GAROB DEVELOPMENTS LIMITED

PROPOSED CHANGE OF USE, FROMER CO-OP, WELL STREET, CEFN MAWR, WREXHAM

TN03 – RESPONSE TO LHA COMMENTS

4TH JULY 2023

title
PROPOSED SITE LAYOUT
SWEEP PATH ANALYSIS
FTA DESIGN 10M RIGID VEHICLE

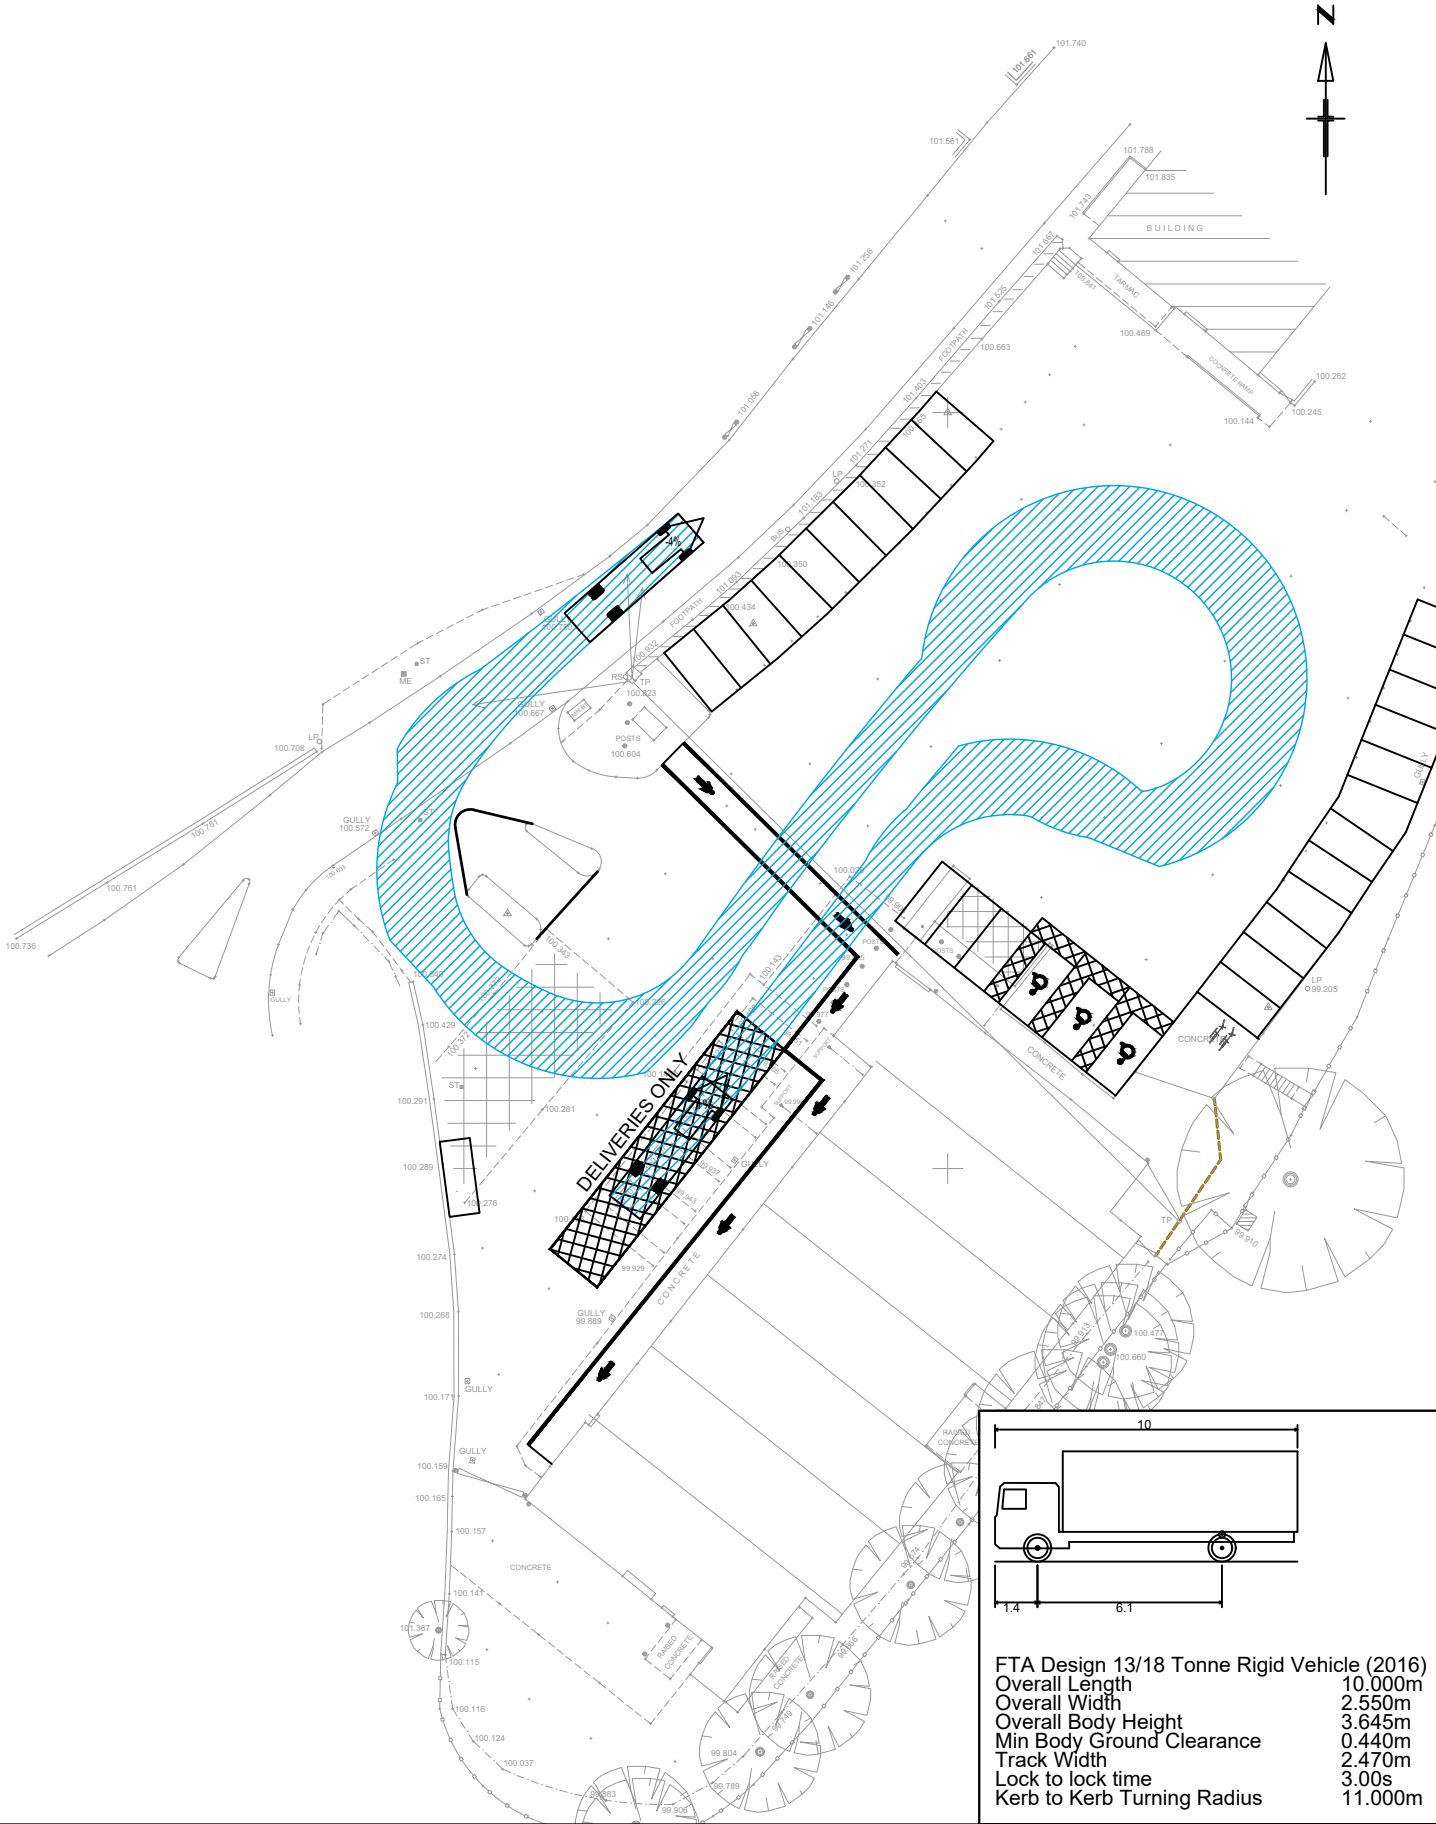
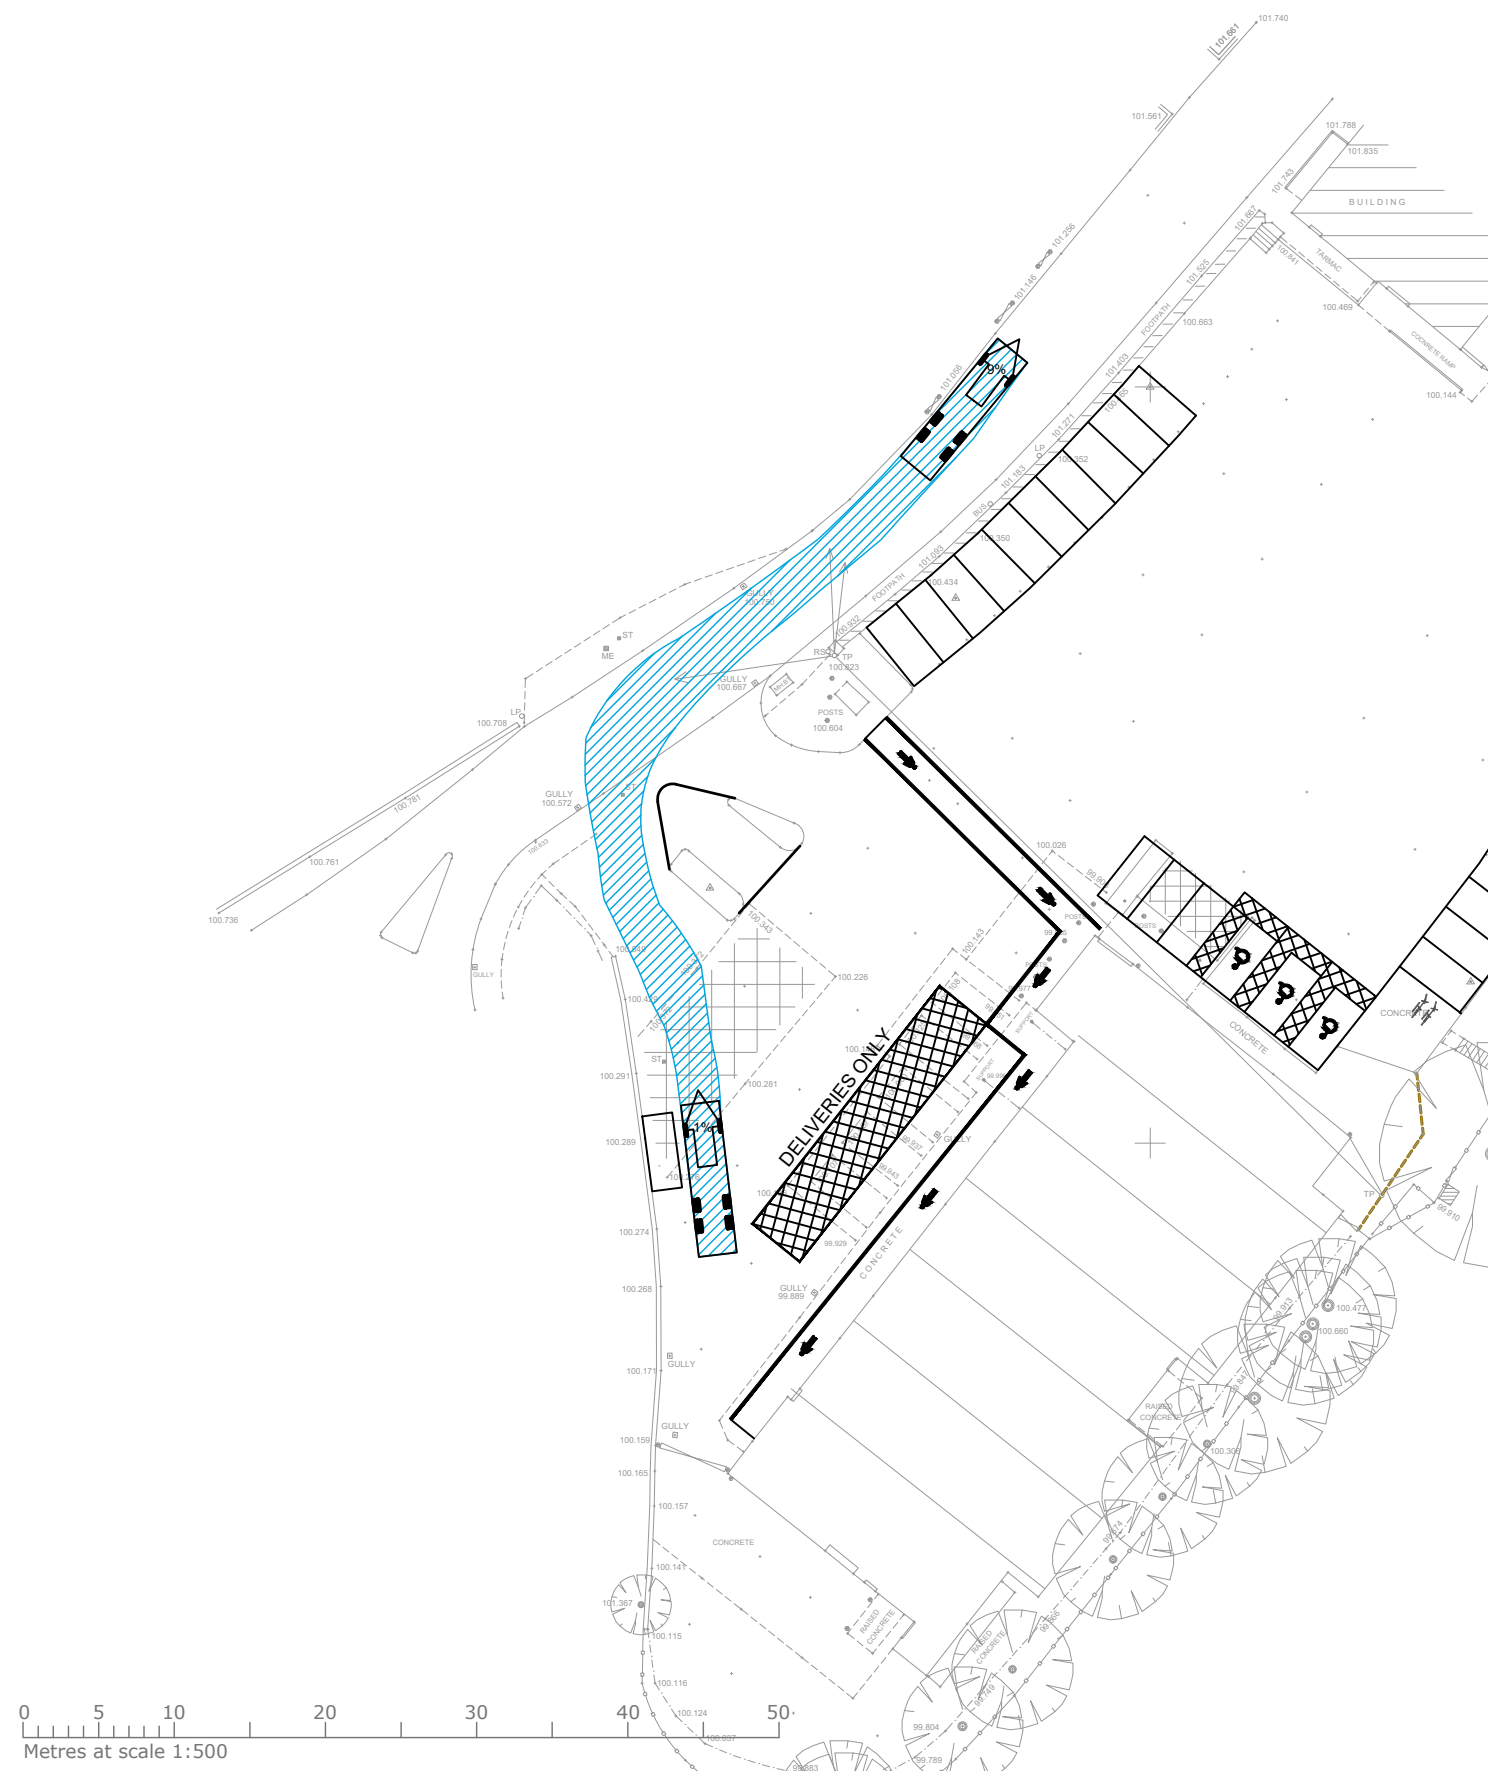
2. Swept path analysis has been provided for both articulated and rigid HGV's both of which are permitted under the current site classification. We note our agreement that adjustment to the central islands may be necessary, which we can agree in due course via a pre-commencement condition as noted below. These alterations may provide central refuge to pedestrian traffic given the size of the opening.

2. Deliveries and servicing of the proposed premises

- 4.6 A marked dedicated delivery and servicing area will be situated fronting the western side of the building. The swept path analysis at Appendix 2 demonstrates that 16.5m articulated and 10m rigid vehicles are able to manoeuvre within the site.

title
PROPOSED SITE LAYOUT
SWEEP PATH ANALYSIS
REFUSE VEHICLE

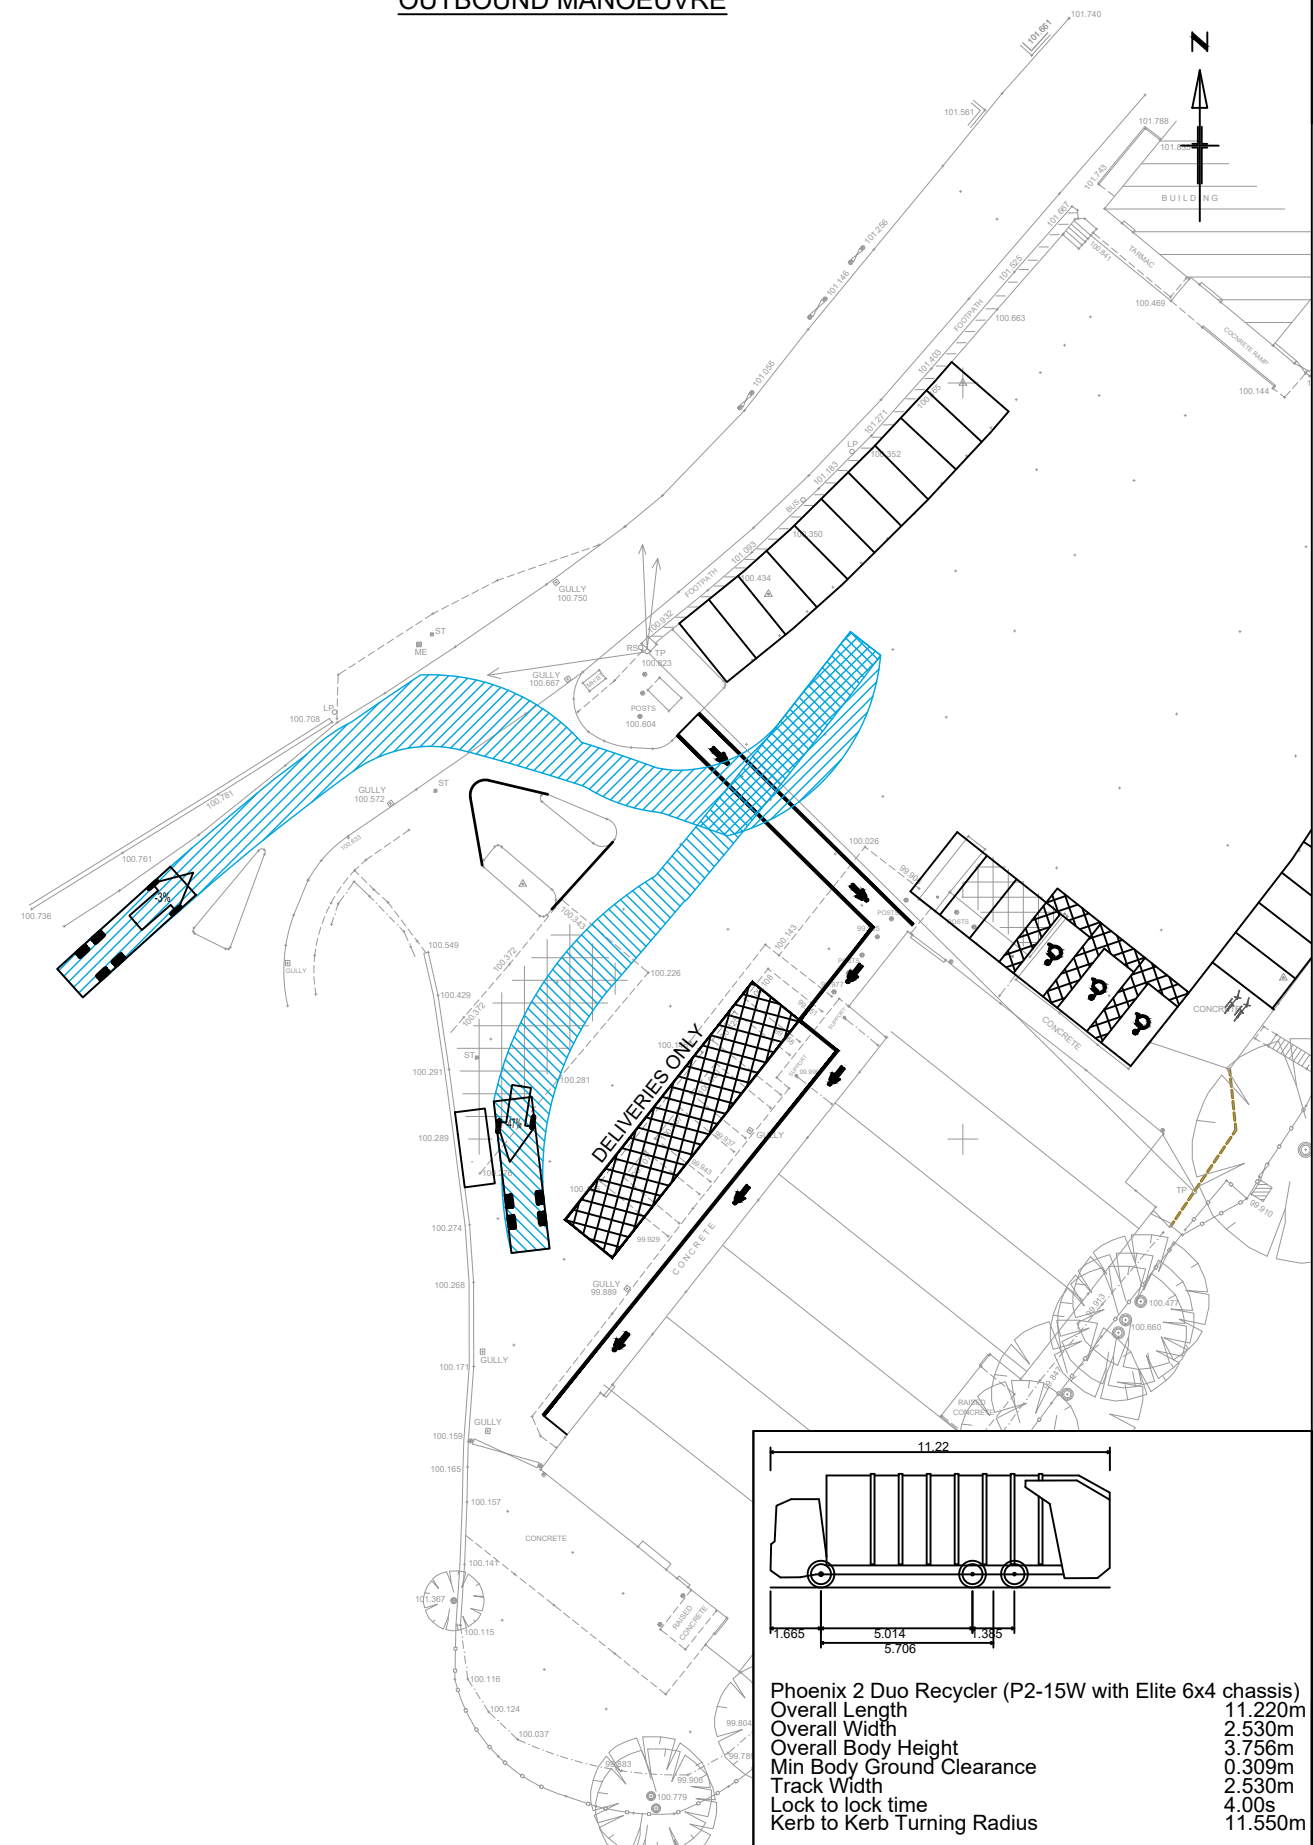
5. Refuse Collection

- 4.9 Refuse collection is proposed to take place within the site at the refuse collection point on the southern boundary of the site, which is identified on the proposed site plan. Refuse vehicles will be able to manoeuvre within the site to undertake this, which is demonstrated by the swept path analysis at Appendix 2.
